17-37 WILLIAM ROAD | LONDON

SECTION 96A APPLICATION: DESIGN & ACCESS STATEMENT

24158-56T-P8-XXX-R-A-001-P04
05.02.2025

B / Proposed Level 01-03 Floor Plan

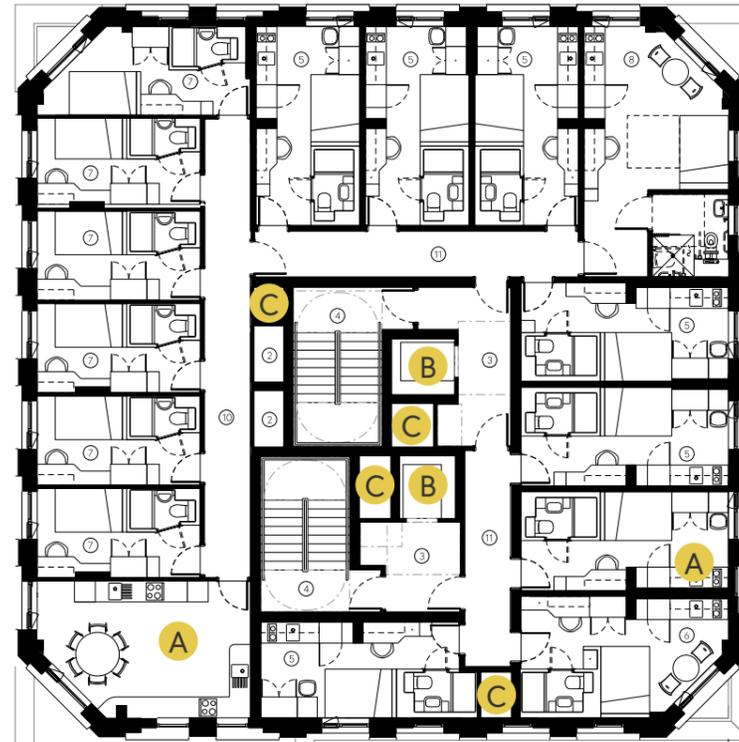
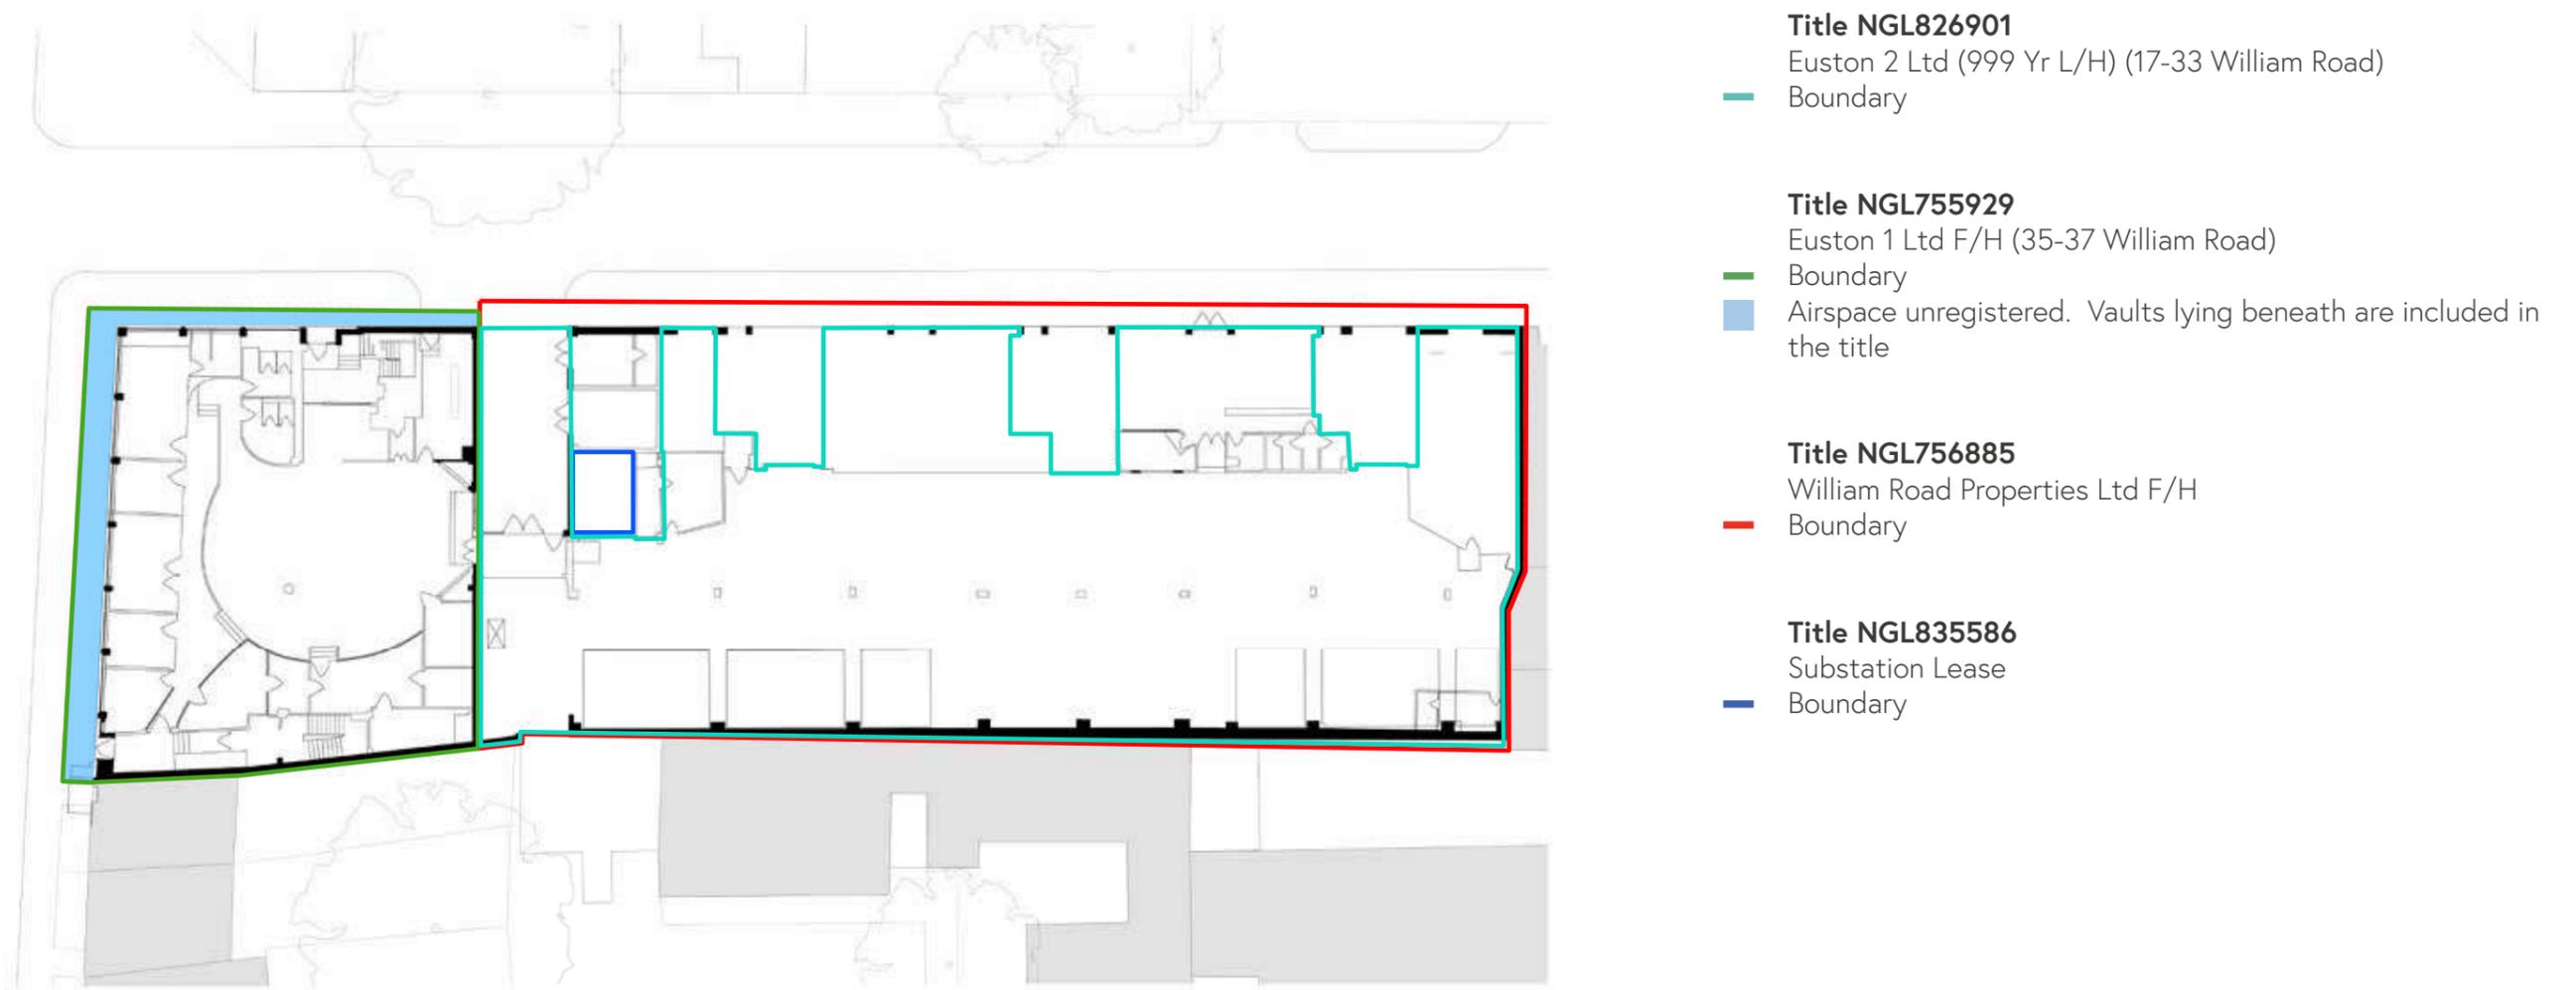
- A. Escape from an inner bedroom via a small room containing a kitchen and through the 1.8m distance away from cooking facilities is removed through provision of either studio accommodation with cooking facilities opposite wall to the front door or shared kitchen accessed via a shared corridor at the far end of the apartment and protected with self closing fire doors and fire rated construction.

- B. Provision of two lifts addressing the same protected lobby does not offer step free evacuation to the second stair. This is addressed by retaining the provision of two lifts but split to address each stair lobby offering dual evacuation and fire fighting functionality.

- C. Mechanical ventilation smoke shafts are provided to all corridors and lobbies which challenges pressurisation techniques where natural smoke ventilation supports the stair lobby to provided replacement air to the negatively pressurised corridor. This is addressed by providing larger natural smoke ventilation to each stair lobby so support the mechanical ventilation to each corridor.

- D. Stair lobbies should not be accessed directly from sleeping accommodation. This is addressed by ensuring bedroom doors are all remote from these spaces via a separate corridor.

- E. Doors cannot cross the escape corridor and should open in the direction of escape. This is addressed by increasing the size of each stair to enabling inward opening doors outwith the clear landing area.

A / Proposed Ground Floor Plan - West

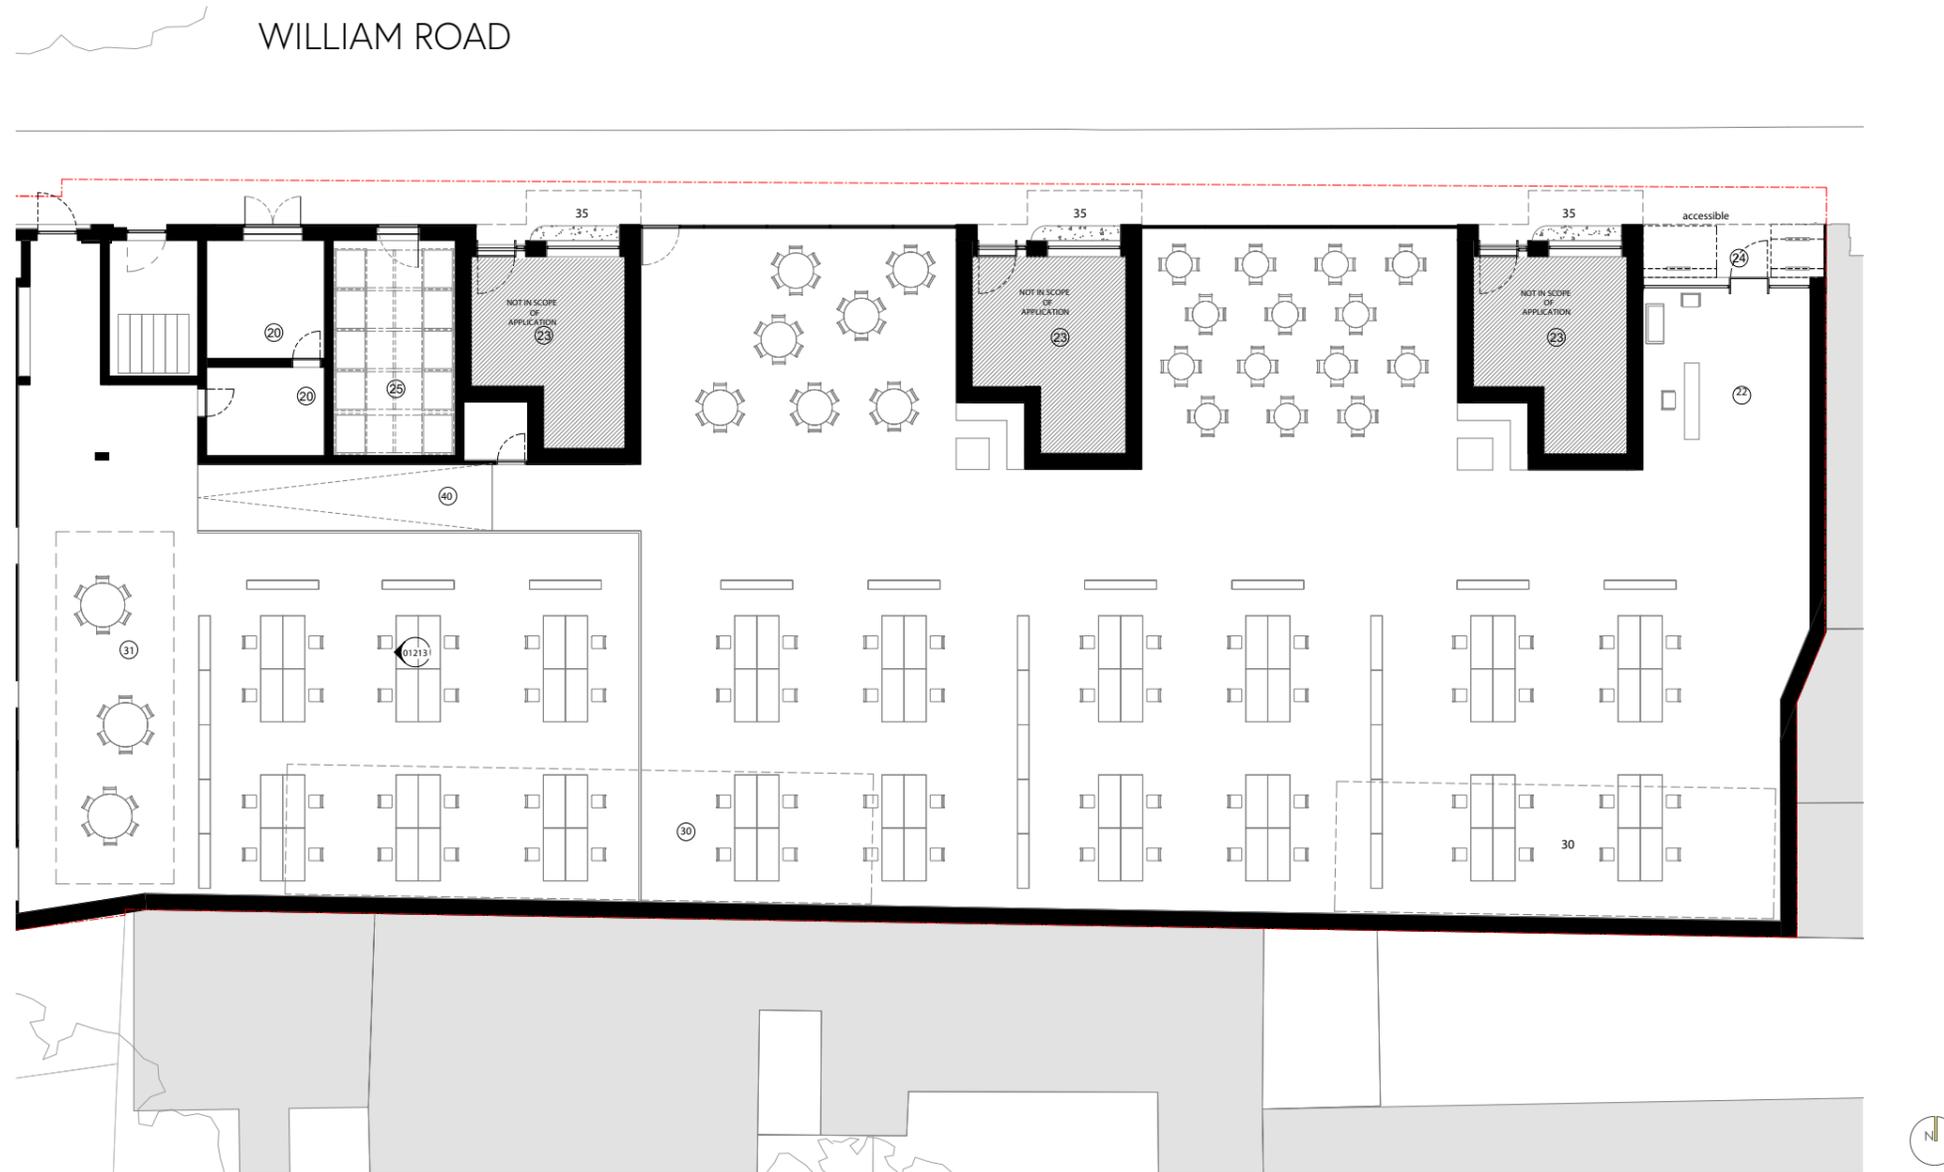
- A. Existing substation, bin and cycle storage areas retained resulting in less disruption to residential accommodation above and technical compliance.
- B. Previous affordable workspace facilities relocated resulting addition of 2 additional studios and additional amenity space for the PBSA.
- C. General changes to core results in reconfiguration and final exit alterations.
- D. New location for final exit from stair
- E. Adjusted Main Entrance door location to suit alternative structural column design
- F. Resultants Affordable Workspace design
- G. Existing courtyard for substation, bin and bike storage access retained as existing.

A / Proposed Ground Floor Plan - East

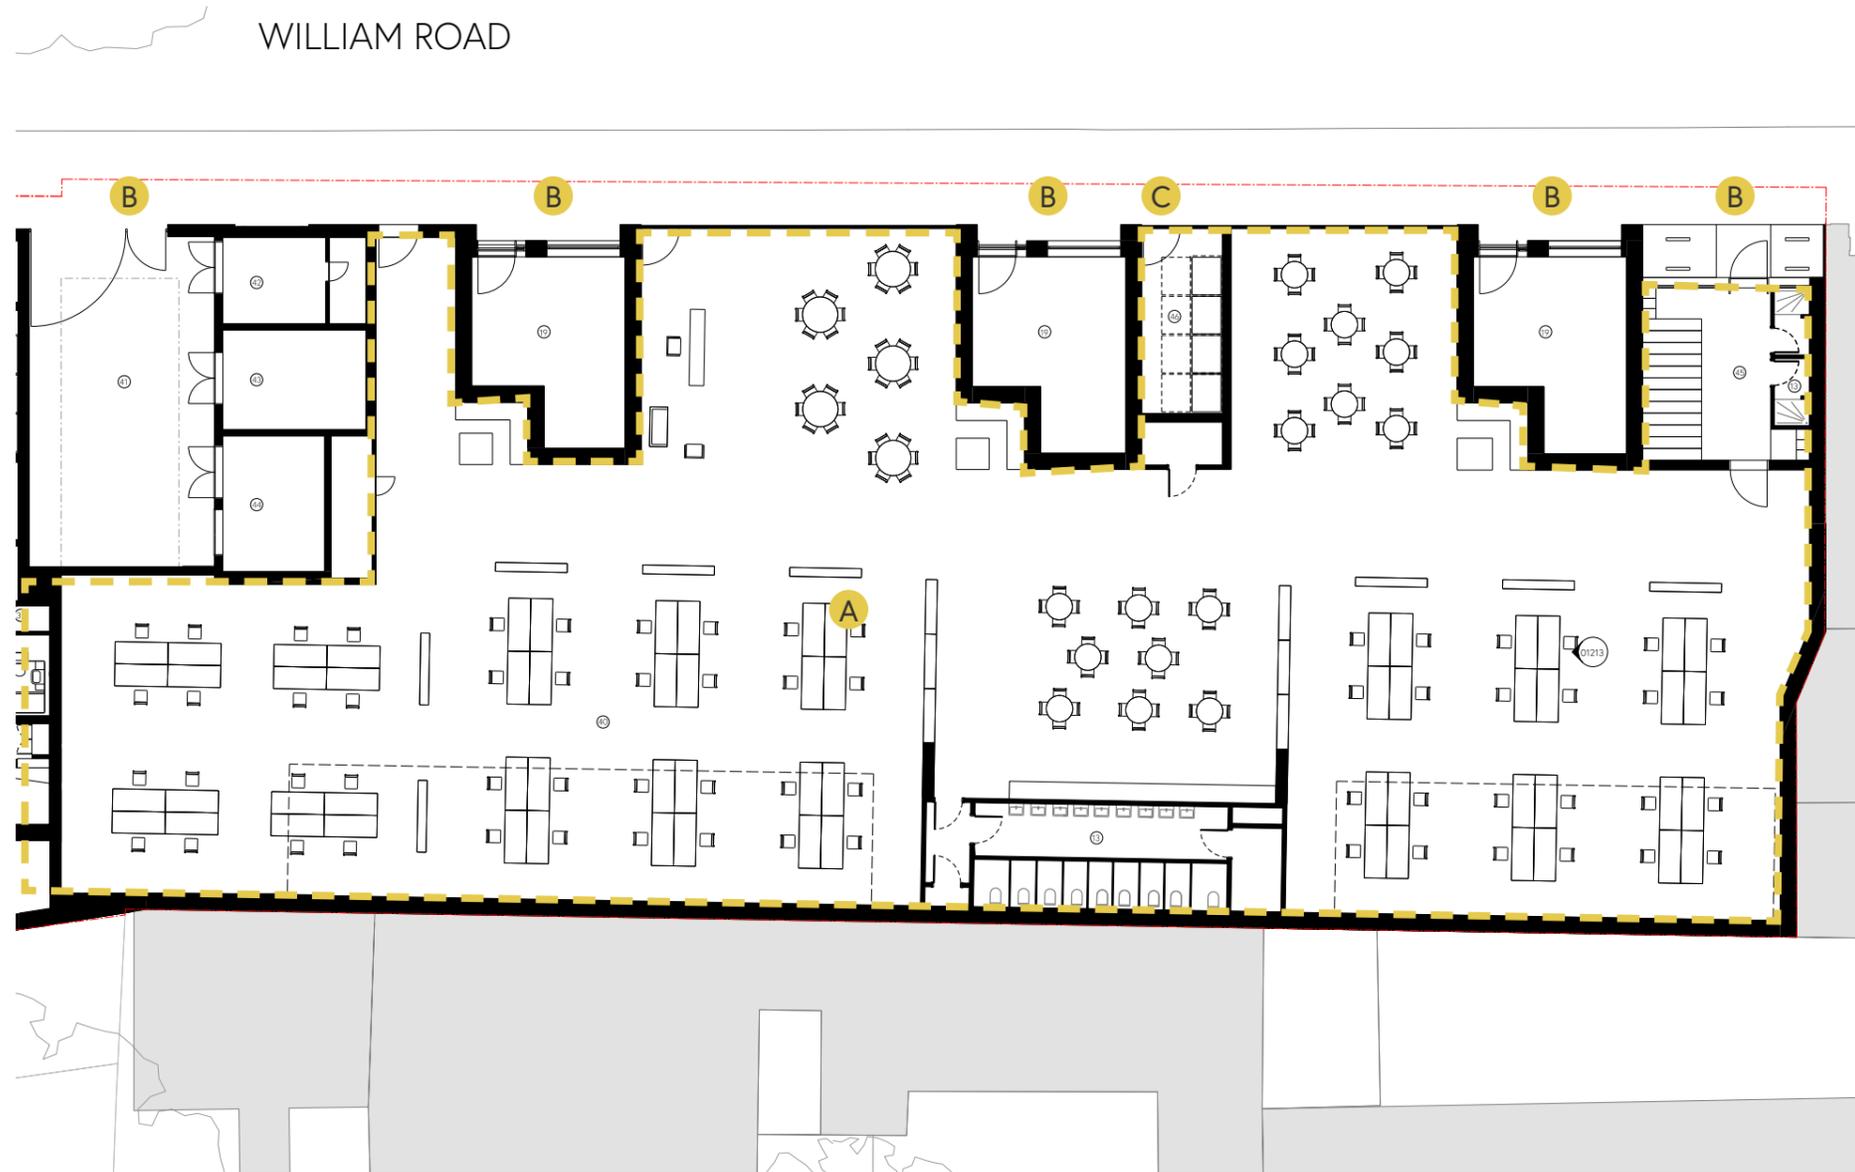
- A. Resultants Affordable Workspace design
- B. All existing entrances retained
- C. Additional door to accommodate bin store
